REQUEST FOR PROJECT REVIEW

Please incorporate the project number somewhere.

RIVERSHORE PATH &
VILLAGE WALKWAYS

Preferred Alternative Section (Typical)

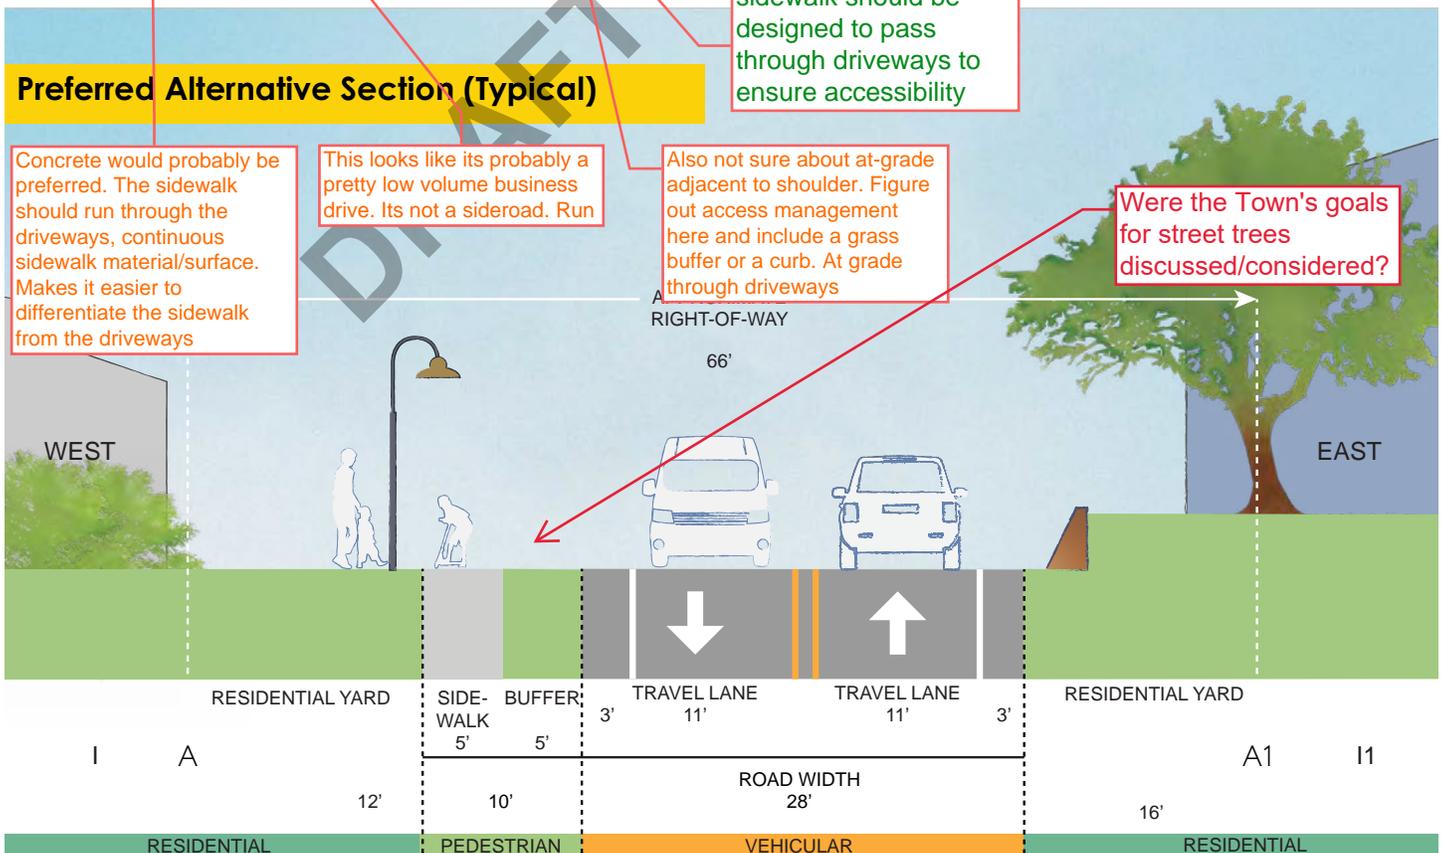
was concrete considered?

sidewalk should be designed to pass through driveways to ensure accessibility

Also not sure about at-grade adjacent to shoulder. Figure out access management here and include a grass buffer or a curb. At grade through driveways

Concrete would probably be preferred. The sidewalk should run through the driveways, continuous sidewalk material/surface. Makes it easier to differentiate the sidewalk from the driveways

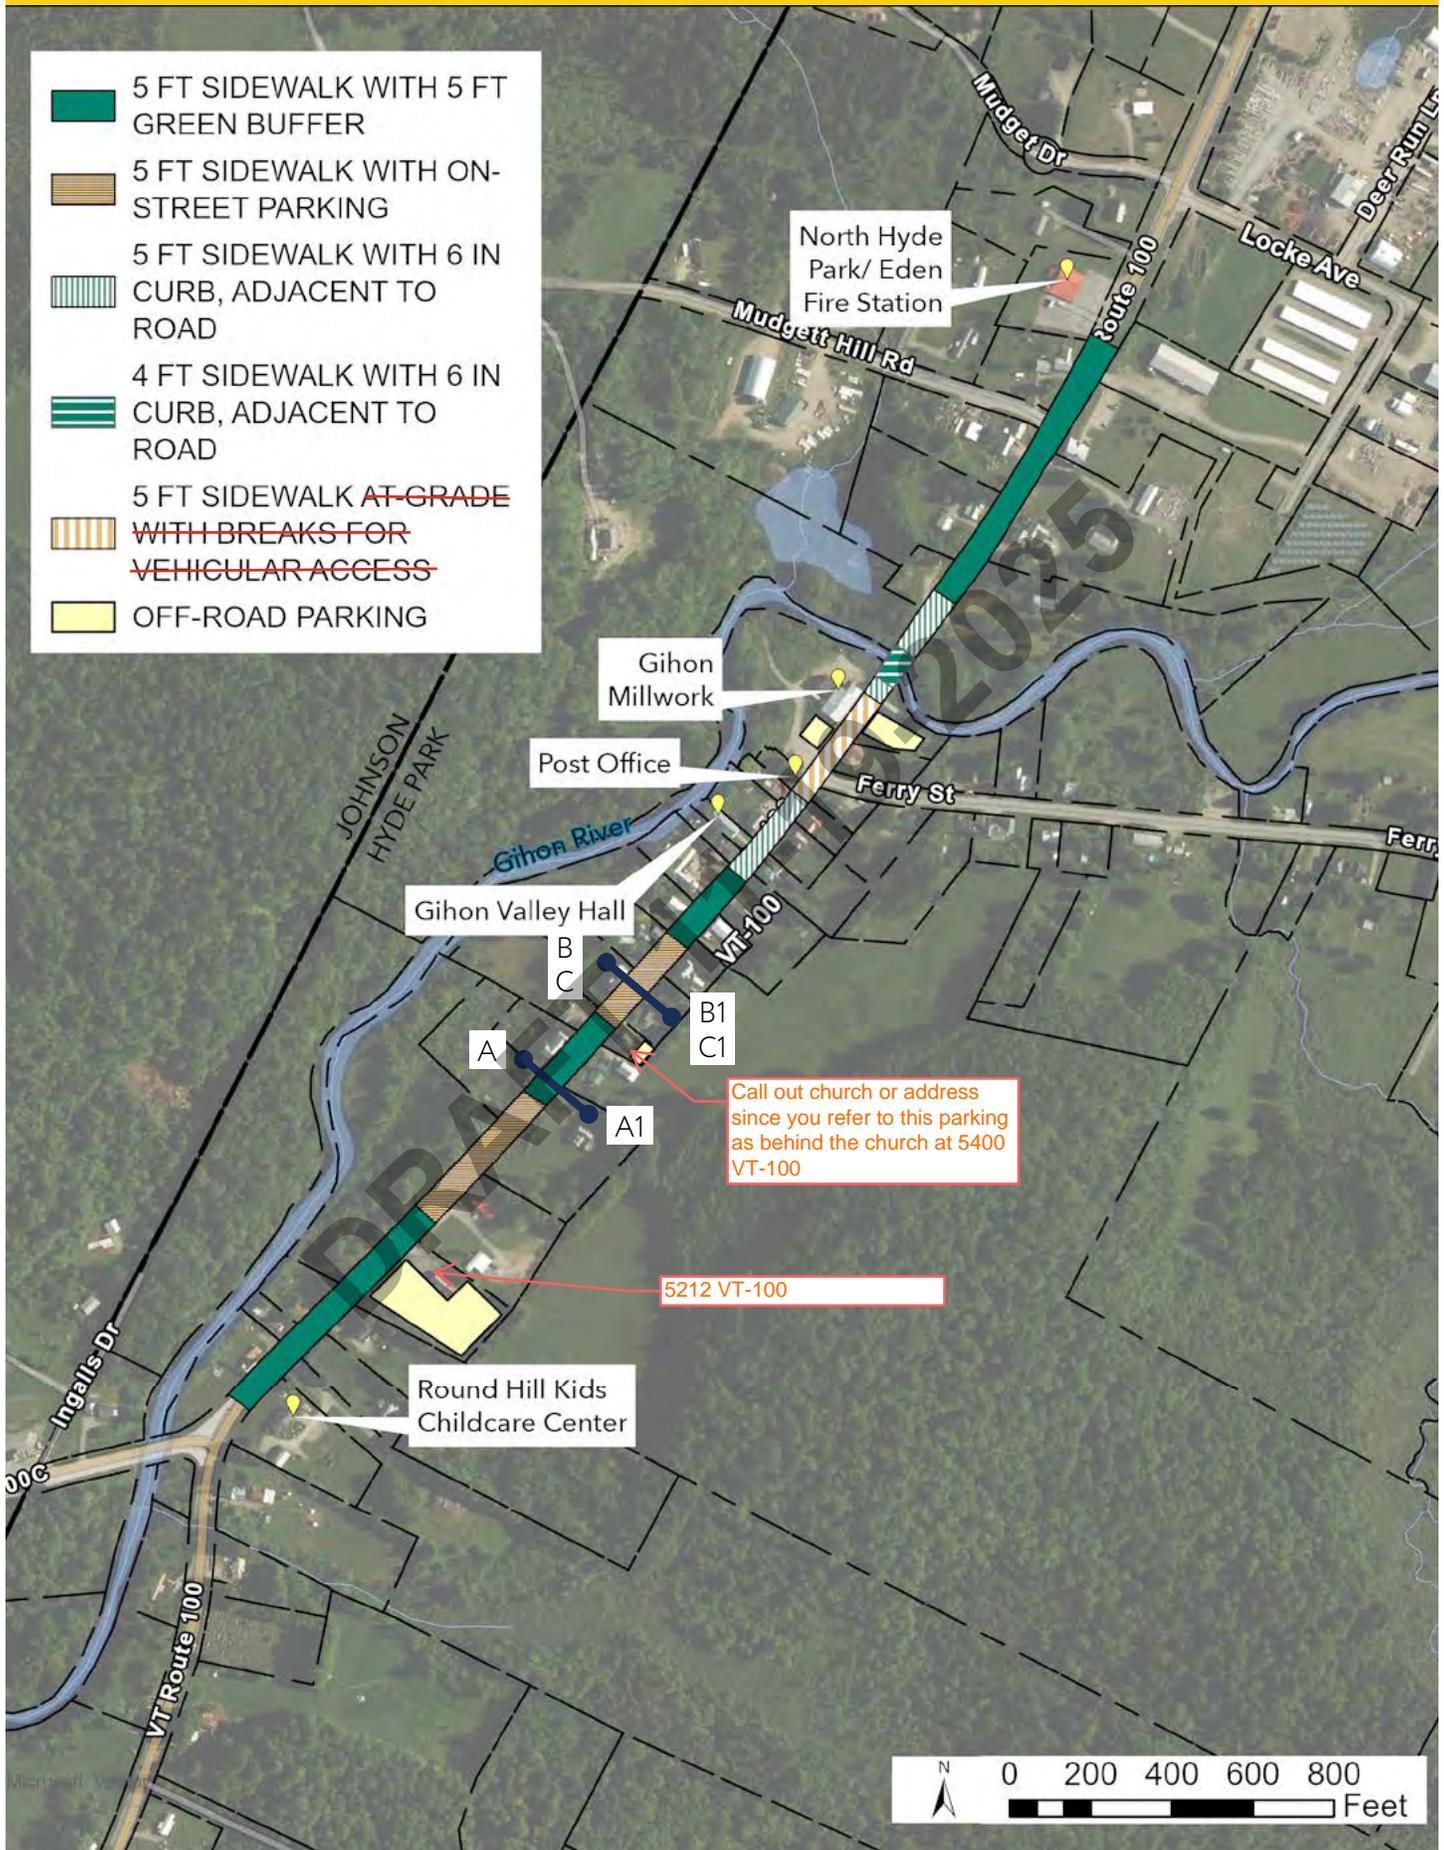
How much nighttime walking do you anticipate in the bustling metropolis of North Hyde Park? Seems like a significant extra expense for a limited benefit.

Preferred Alternative On-Street Parking Section (Typical)

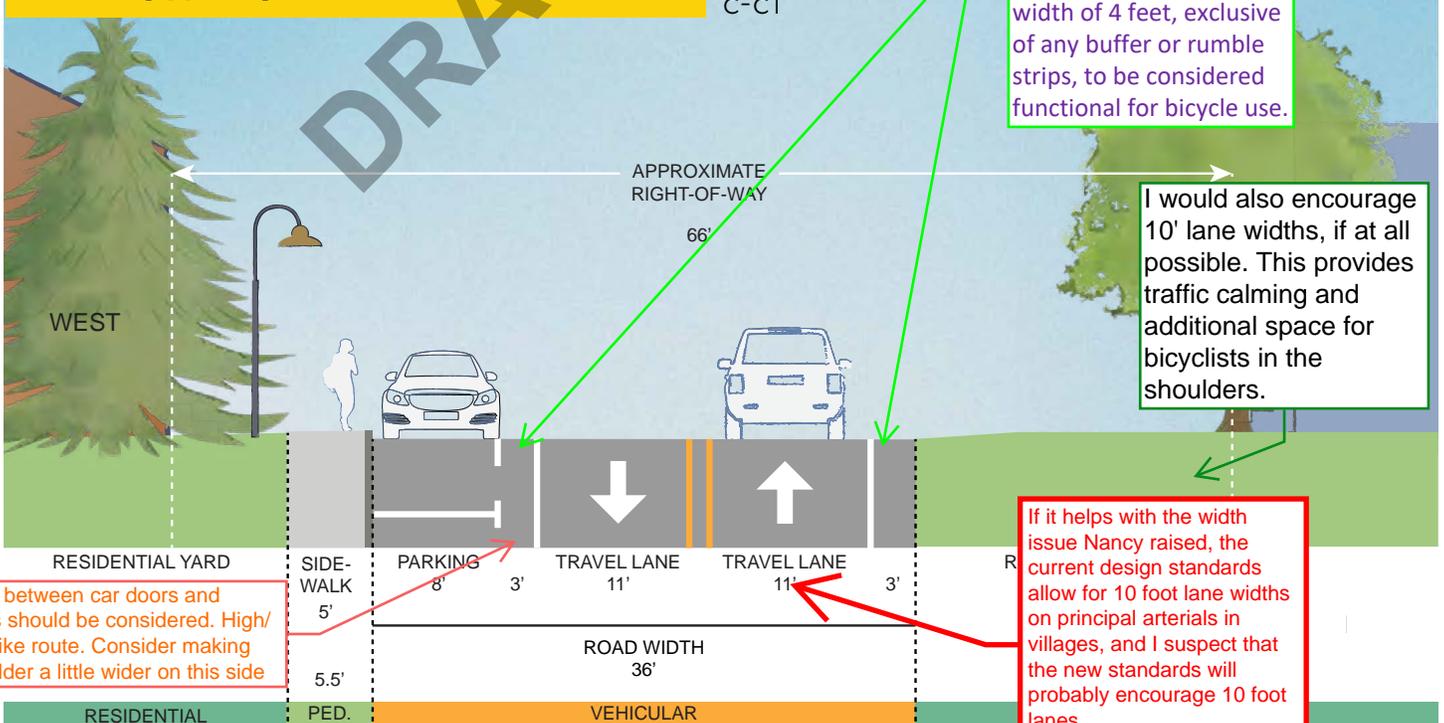
Per the VTrans Bicycle Corridor Priority Map, VT 100 and VT 100C in North Hyde park are considered a high use/priority route.

A paved shoulder area should have a minimum width of 4 feet, exclusive of any buffer or rumble strips, to be considered functional for bicycle use.

Map 04: Utilities

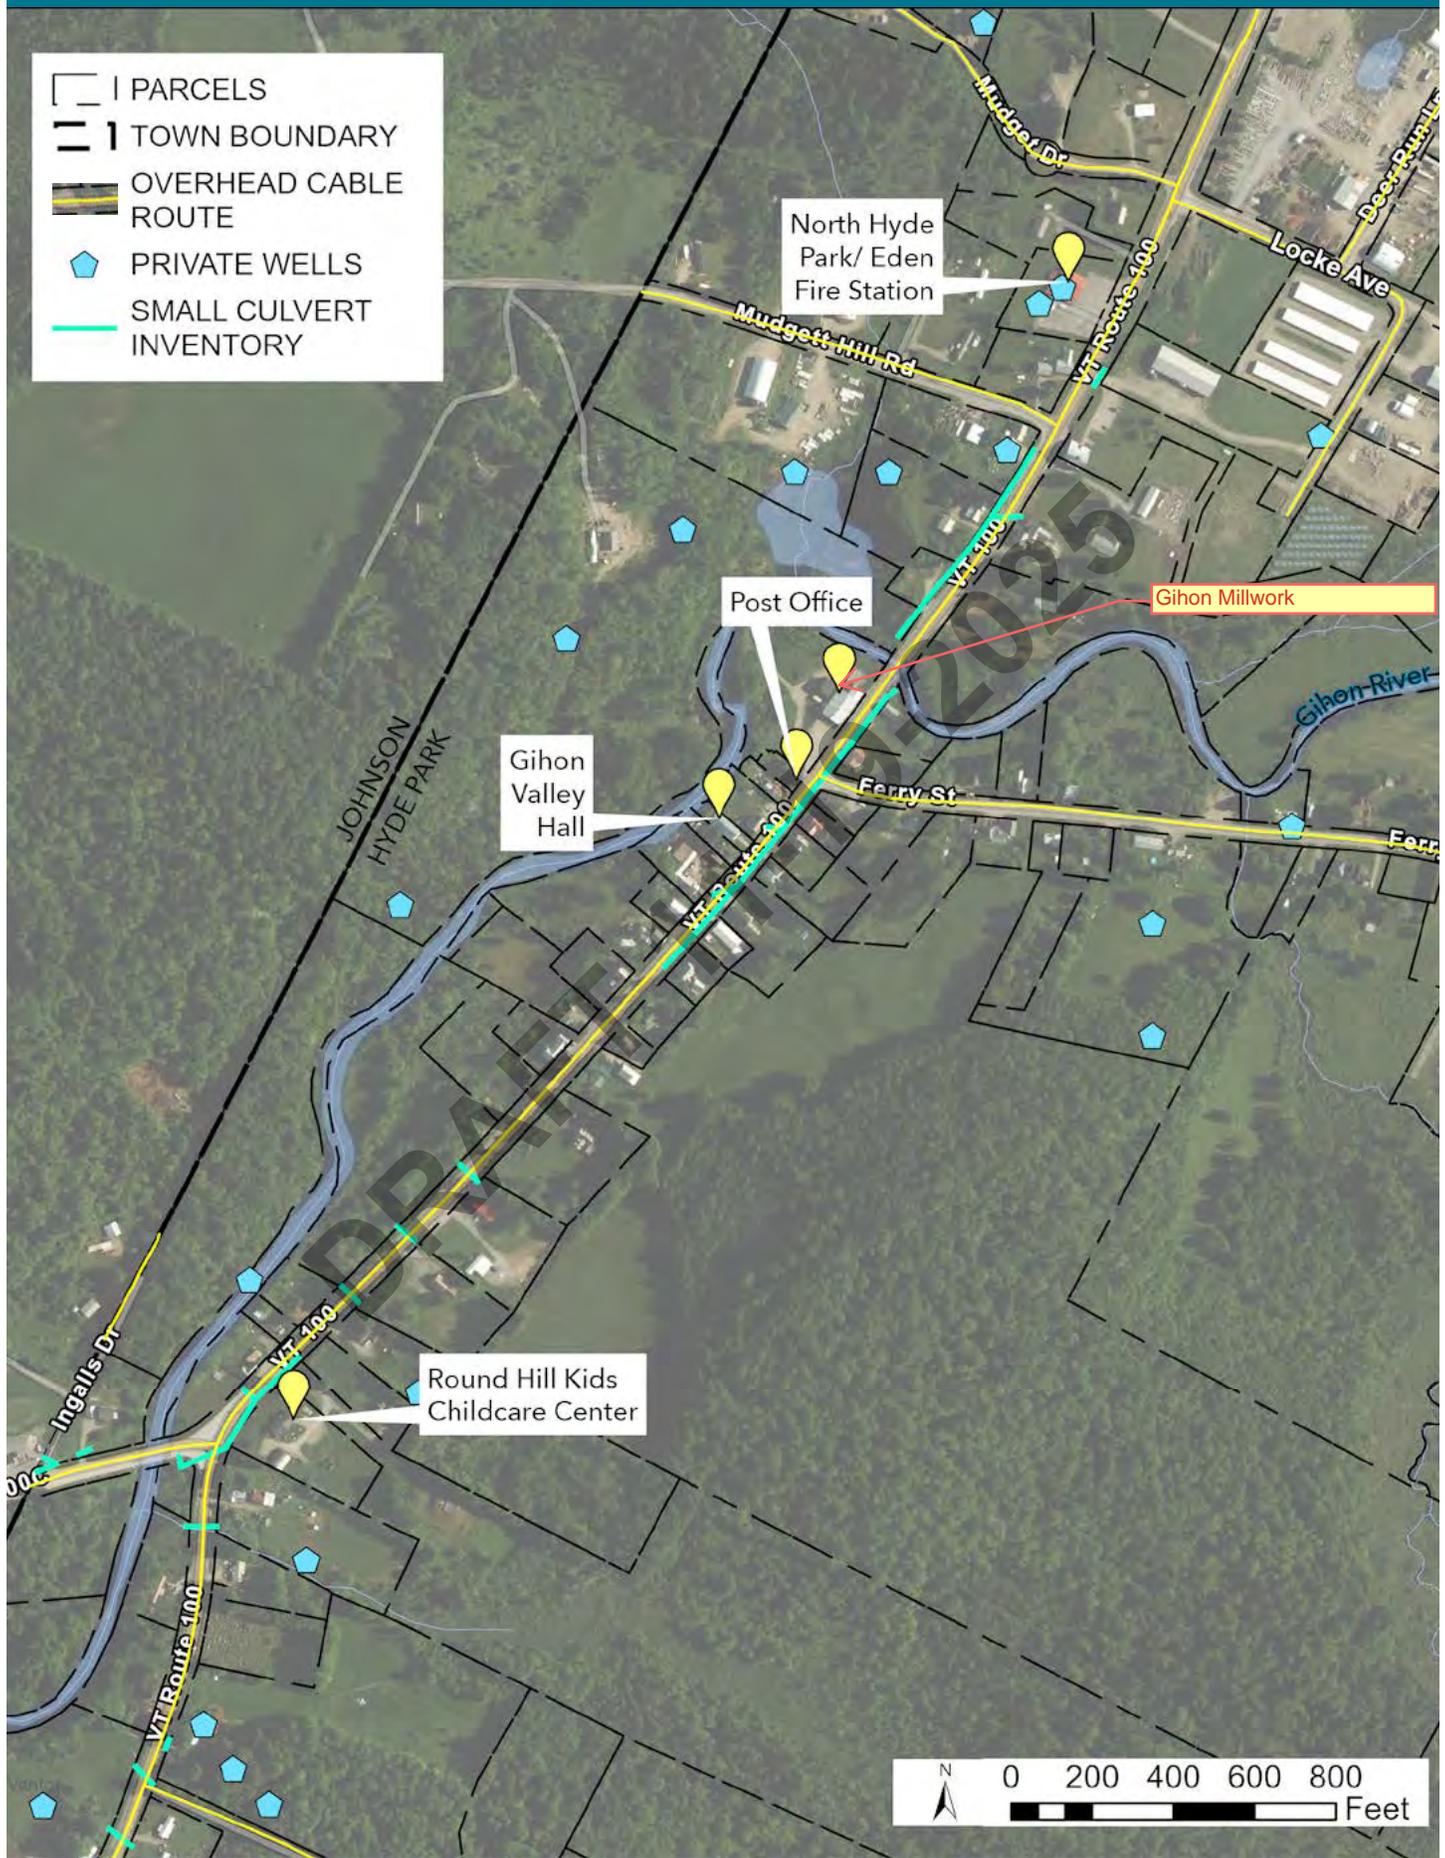
Are there any catch basins or other closed drainage infrastructure? Or is it all open culverts?

Image 4.2.4. Notable features in the area.

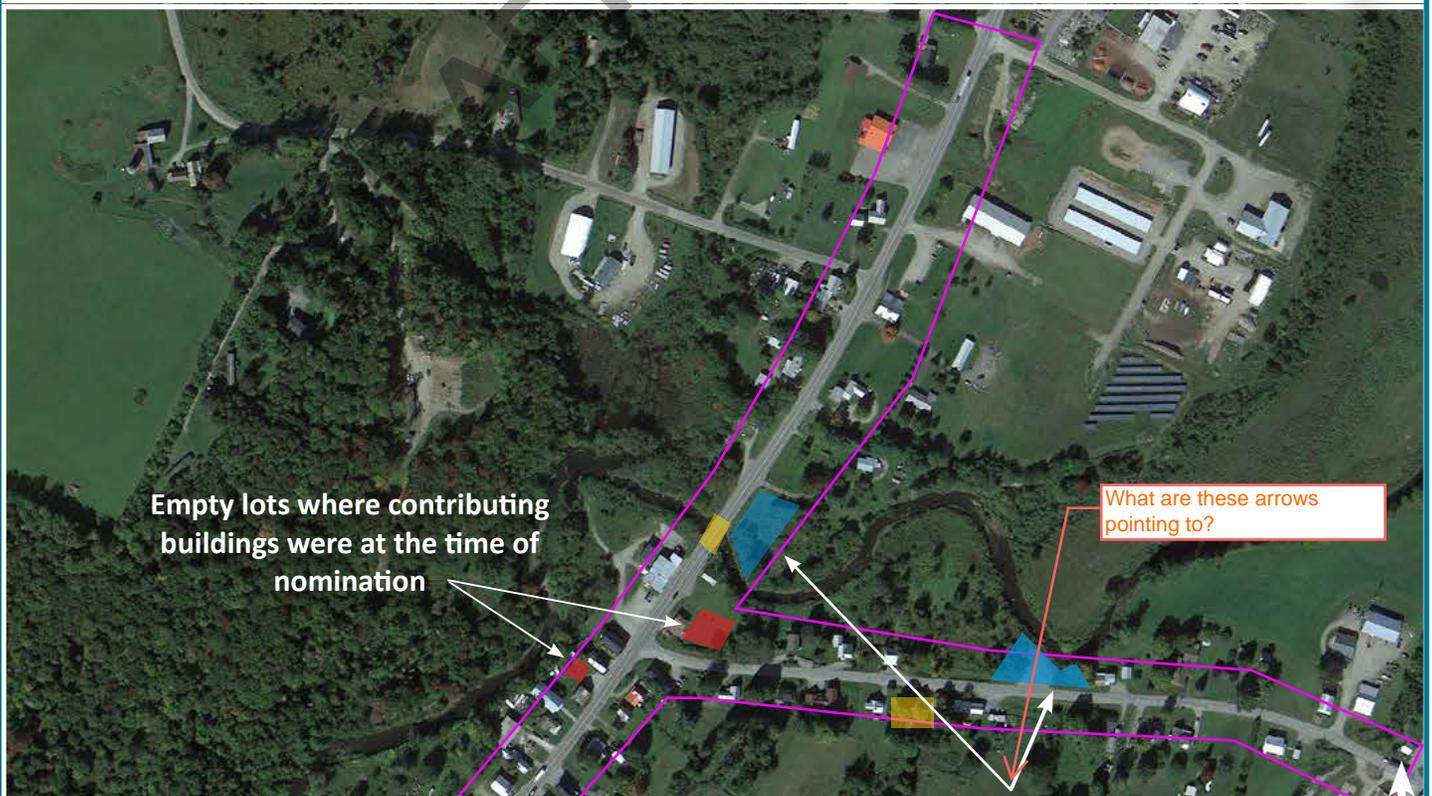
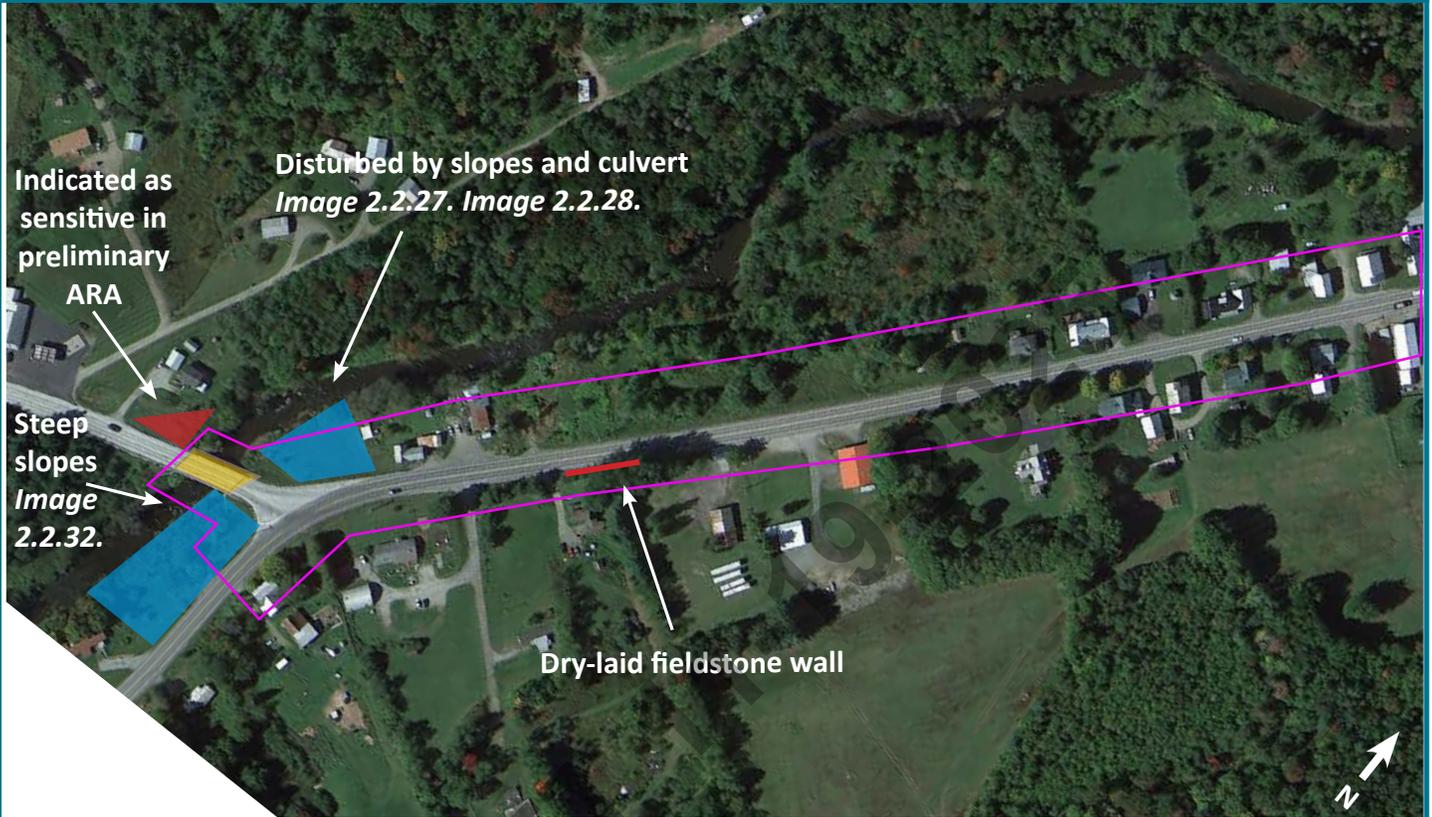
Why preliminary ARA?
Should it refer to ARA from
previous scoping project/
year?

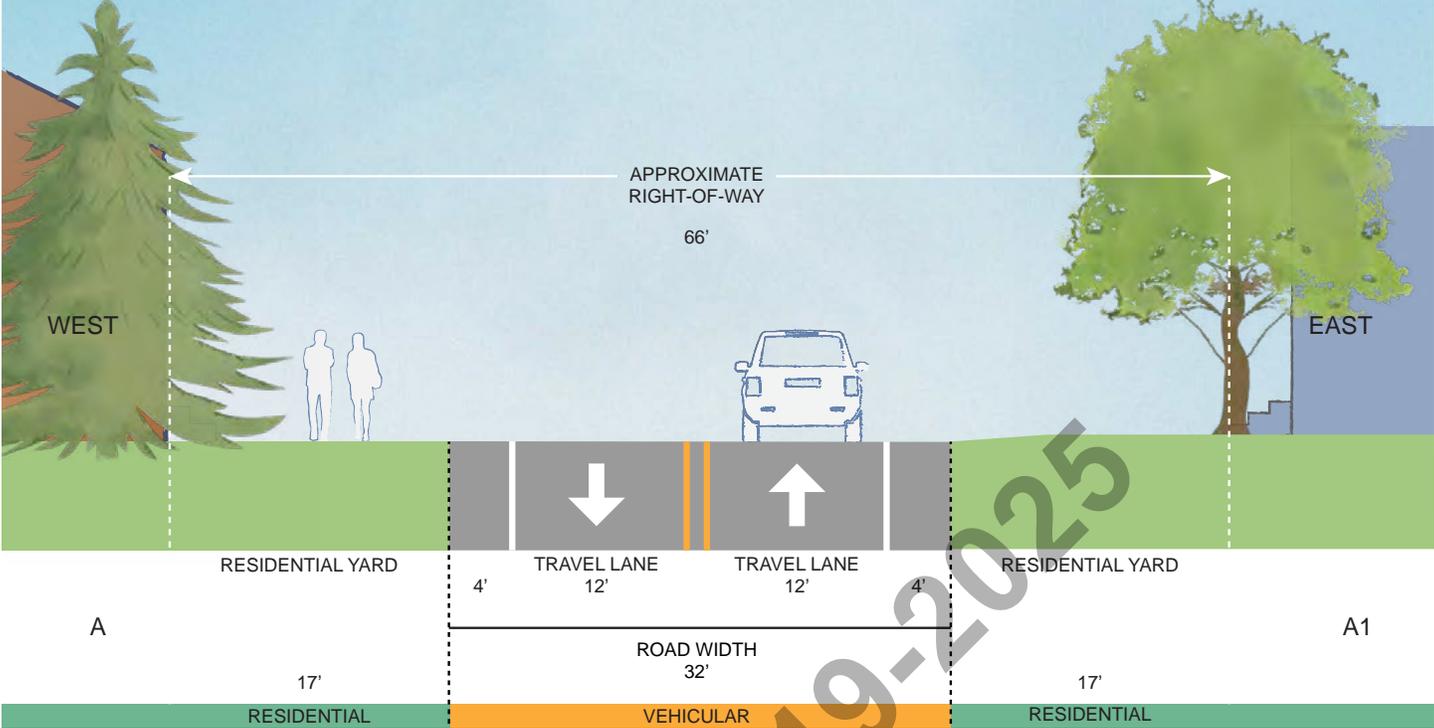
Unfortunately weeds will still grow in, and it will need to be mowed. It would be unrealistic to weed this, so we should expect mowing.
